Product Change Notification

MultiTech Dragonfly™ 3G HSPA+ Embedded Cellular Modems and SoMs

PCN 02042020-00

IV. Current and New PCB Versions

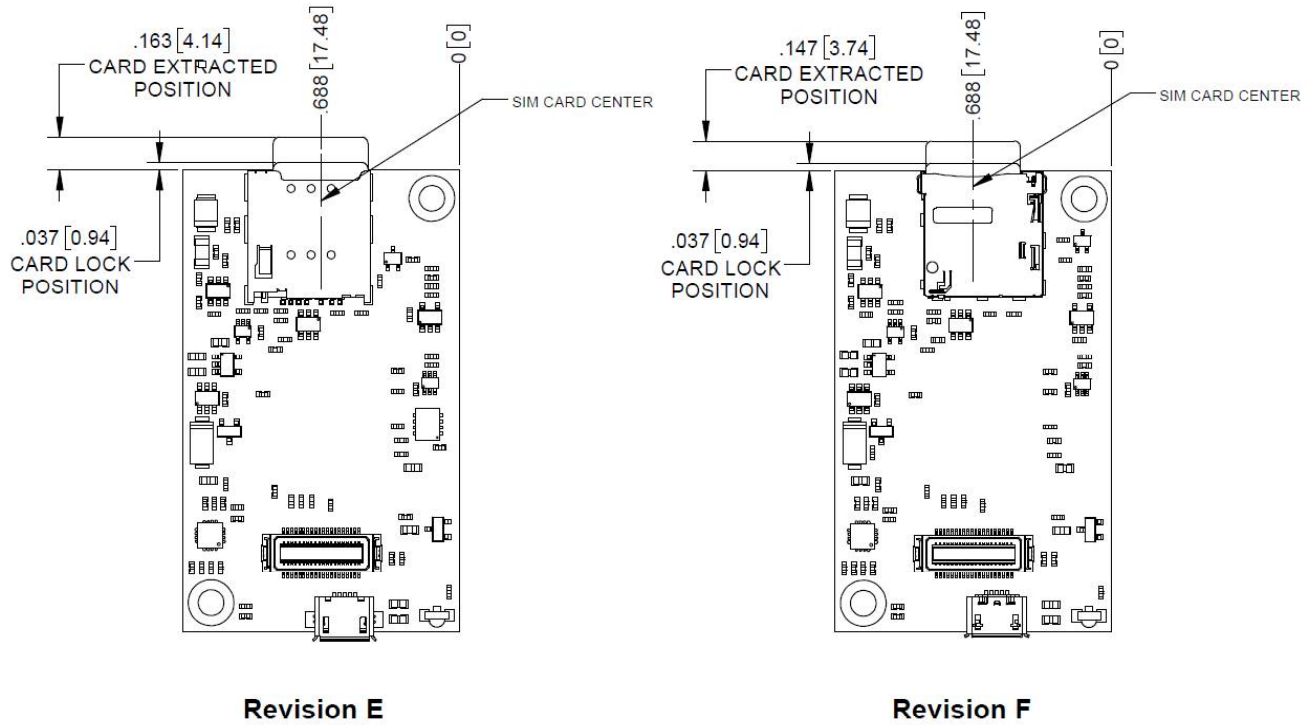
Minor Printed Circuit Board (PCB) revision to accommodate a new micro SIM holder.

MultiTech has completed a minor board revision to the PCB used for the Dragonfly MTQ-H5-B0x family. The revision was needed to provide a SIM holder that has been identified as being more reliable. The spring mechanism in the old SIM holder may fail with repeated SIM insertions and ejections. The location for the SIM holder opening has not changed. (See drawings in Section IV)

Any MTQ-H5-B0x with a Date of Manufacture (DOM) of February 3, 2020 or later will include the new PCB and SIM holder.
